**AGENDA FOR REGULAR MEETING
VILLAGE OF TINLEY PARK
PLAN COMMISSION
February 19, 2015 – 7:30 P.M.
Council Chambers
Village Hall - 16250 South Oak Park Avenue**

**ITEM #1 MAHER FUNERAL HOME (JOHN MAHER, PETITIONER) – 17101 71st AVENUE
– SPECIAL USE PERMIT FOR AN ACCESSORY APARTMENT, FRONT YARD
SETBACK VARIATION, AND SITE PLAN APPROVAL FOR A FUNERAL HOME
(New Item)**

PLAN COMMISSION

The Applicant proposes to convert the former Tinley Park Library, located at 17101 71st Avenue, into a new funeral home facility with a one-bedroom apartment as an accessory use. The proposed apartment use requires a Special Use Permit. As part of the Special Use process, the Plan Commission must review the proposed site plan and elevation changes.

SHEET TITLE:
BUILDING ELEVATIONS

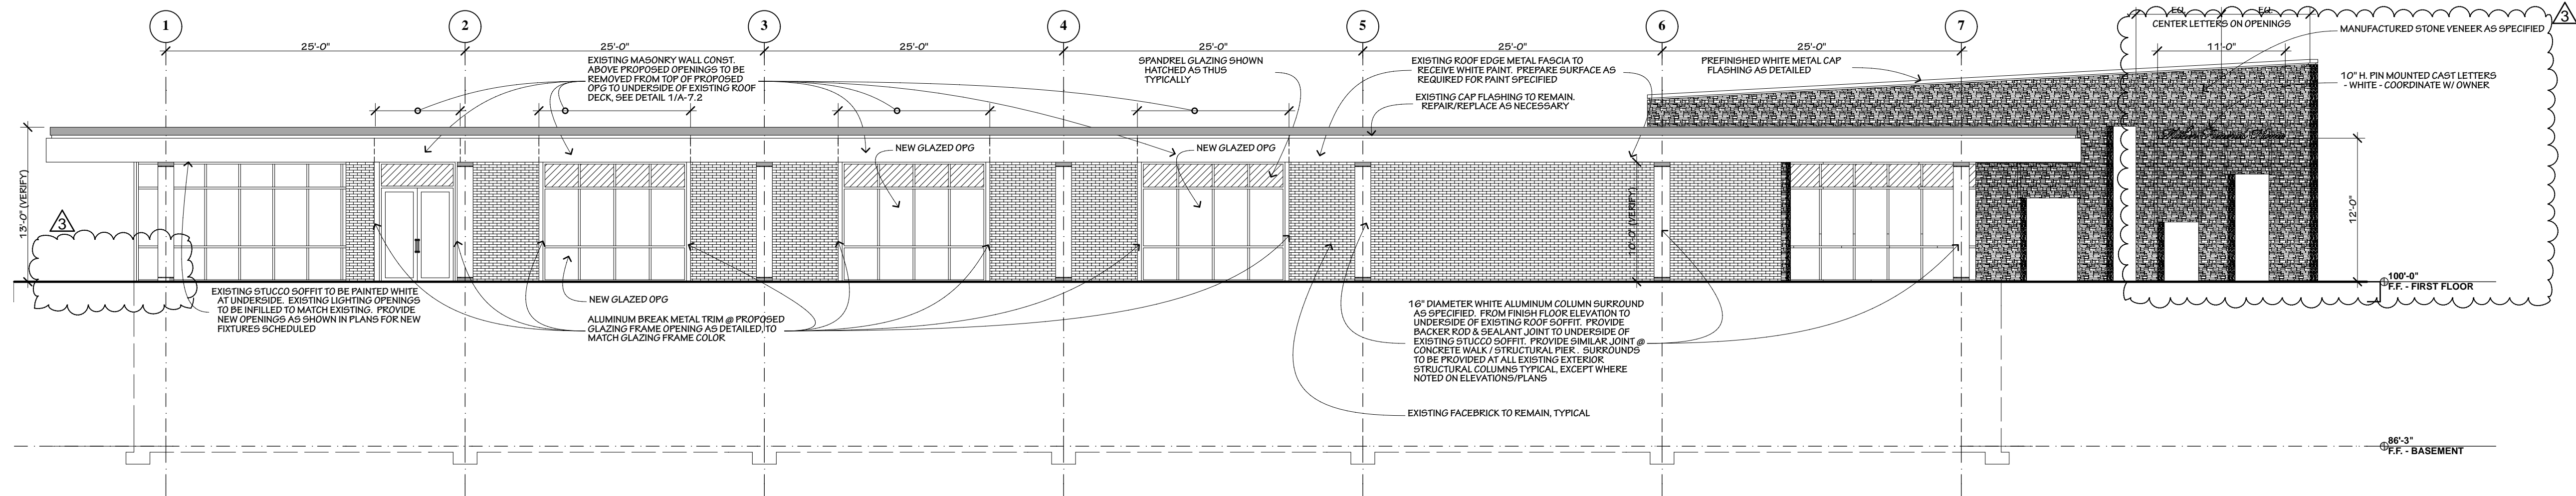
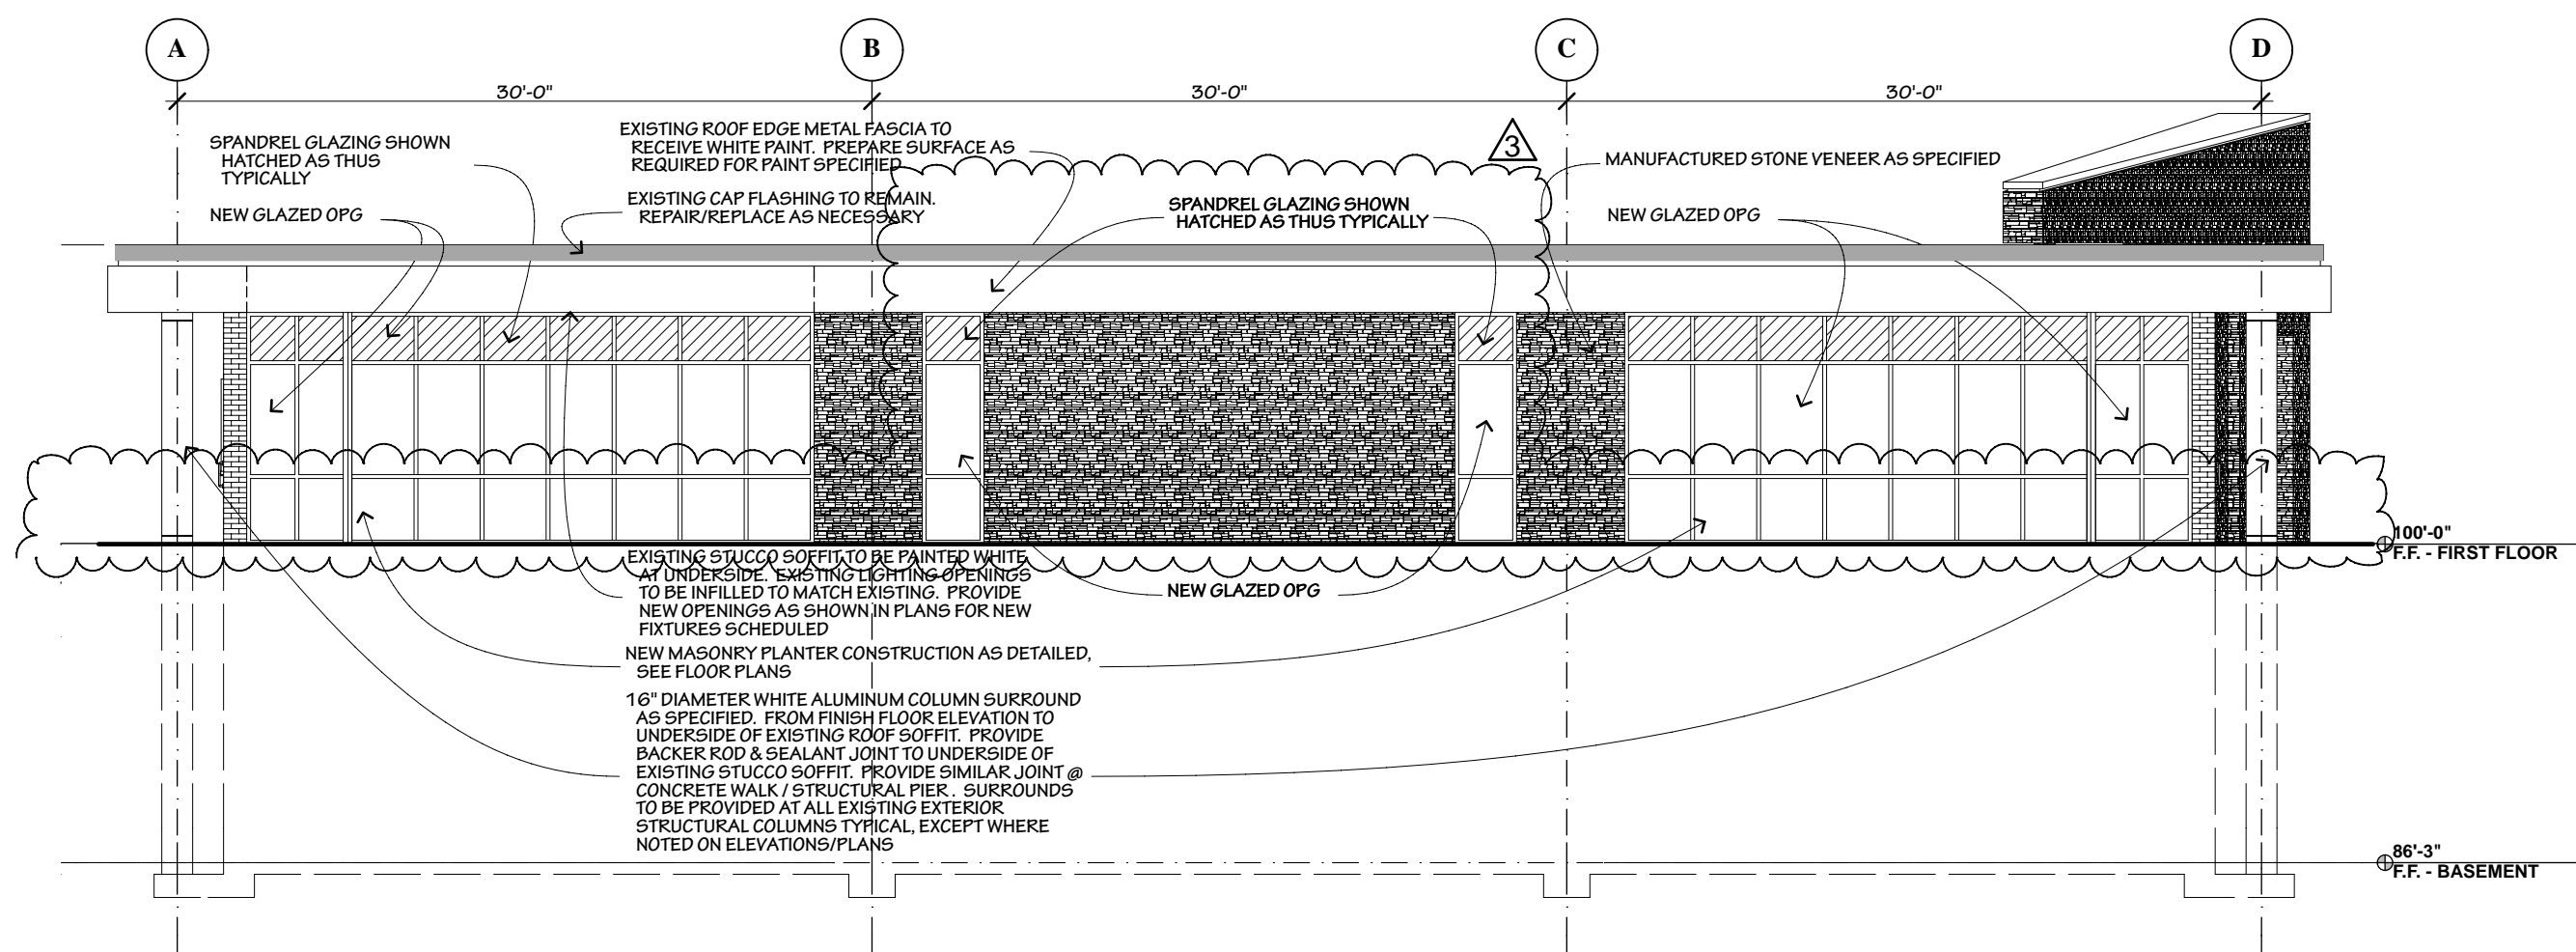
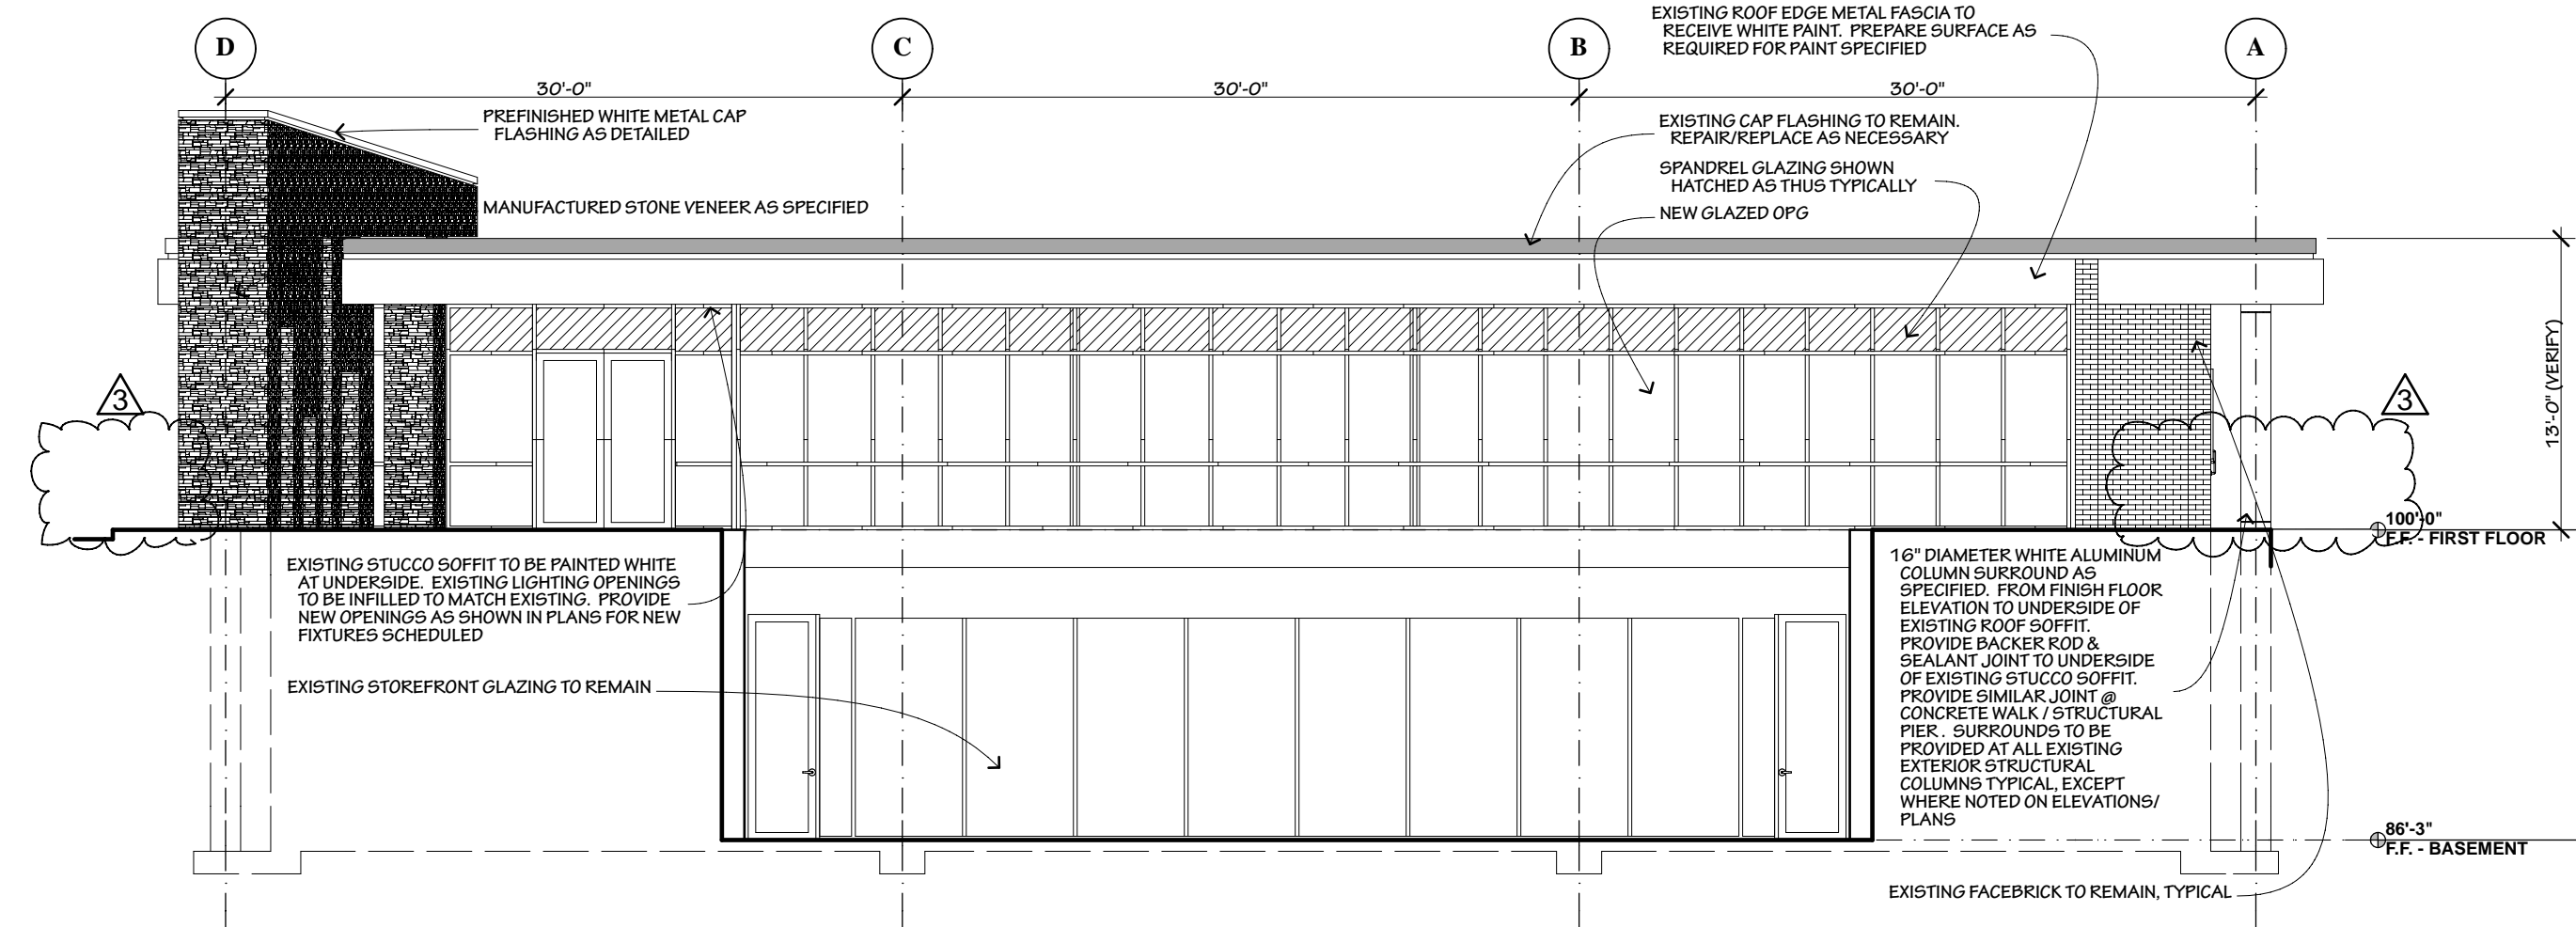
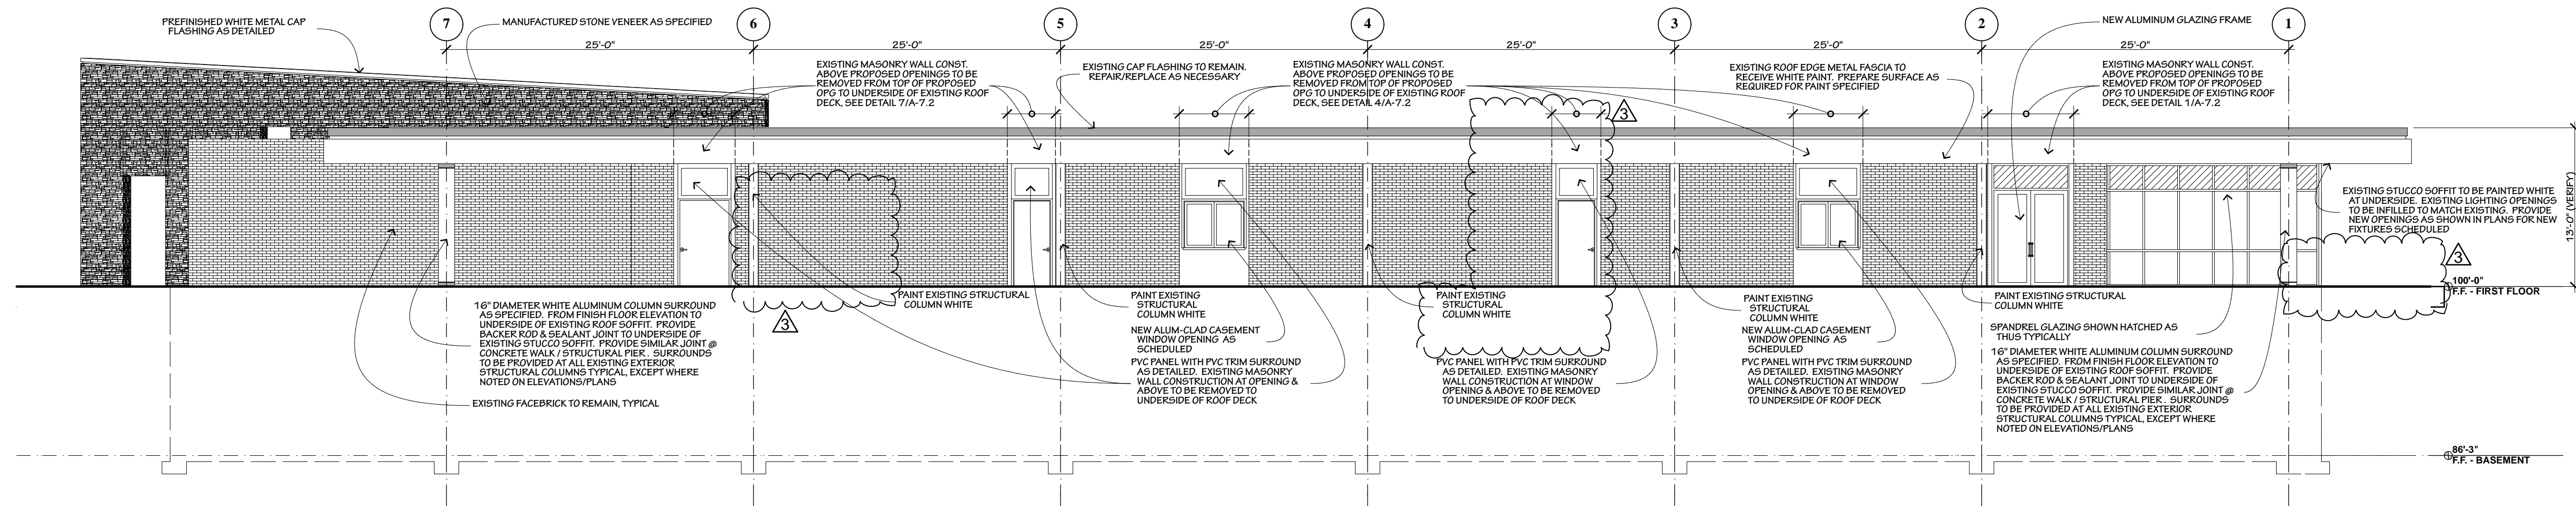
Architecture: The architect has proposed renovations to that existing structure that respect the original modernistic architectural design and style. A new stone veneer on the north façade will provide necessary privacy for the chapel and new glazing has been proposed to replace the existing storefront system which will create a more energy efficient building envelope. The original floorplan was one large open area, the new floor plan provides for a more compartmentalized floor plan and consequently will require new mechanical systems and associated ductwork. A suspended ceiling will conceal the ductwork from view and provide better acoustics for the chapels and offices.

The original façade included floor to ceiling windows. The new design mimics this design but includes a ‘transom’ window that will use Spandrel glass to conceal the required space for the mechanical system. The new window design retains the existing exterior “modern” architectural design of minimal framework, strong horizontal elements, and full height windows.

The Plan Commission has previously expressed concern regarding the use of Spandrel glass. Staff investigated alternate materials however the architect states that Spandrel glass is the best material choice and states that it is consistent with the appearance of the rest of the windows except for its opacity. The architect feels the use of Spandrel glass in this limited area “*lends itself to the original building design by keeping the exterior simple and not introducing another element to conceal the interstitial space.*”
